DEDHAM-WESTWOOD WATER DISTRICT

WHITE LODGE WTP PFAS TREATMENT

DWSRF-16739

ADDENDUM NO. 3

Update to Addendum 2, Question 26:

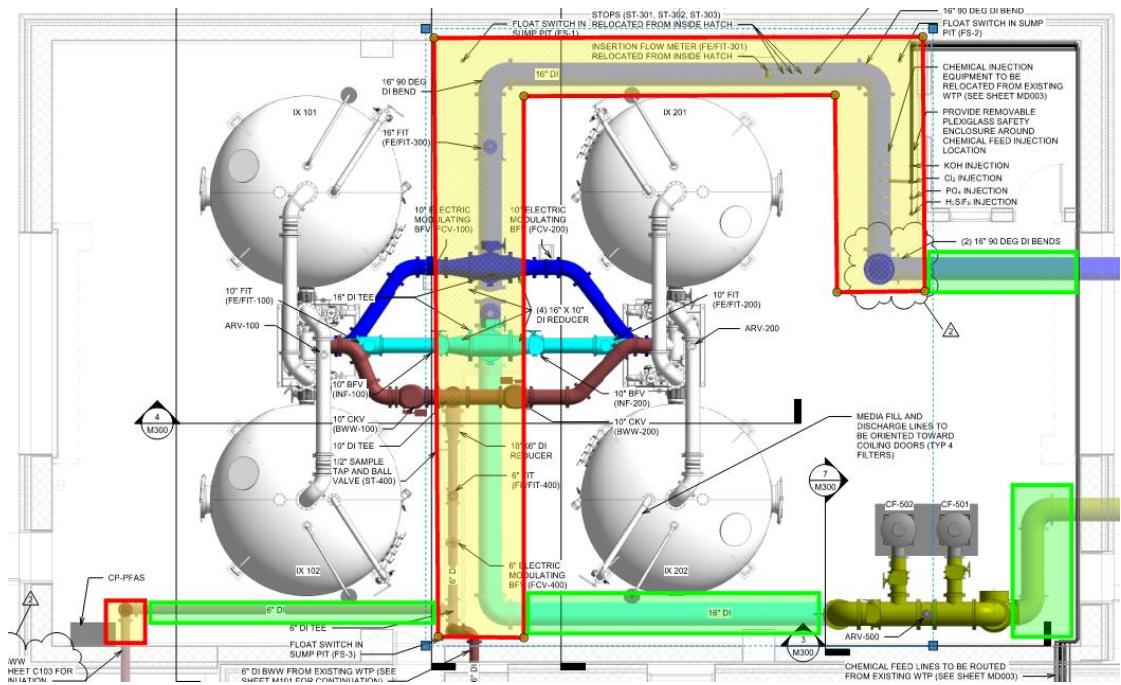
REPLACE THE IMAGE IN THE ANSWER TO QUESTION 26 IN ADDENDUM 2 WITH THE FOLLOWING IMAGE:
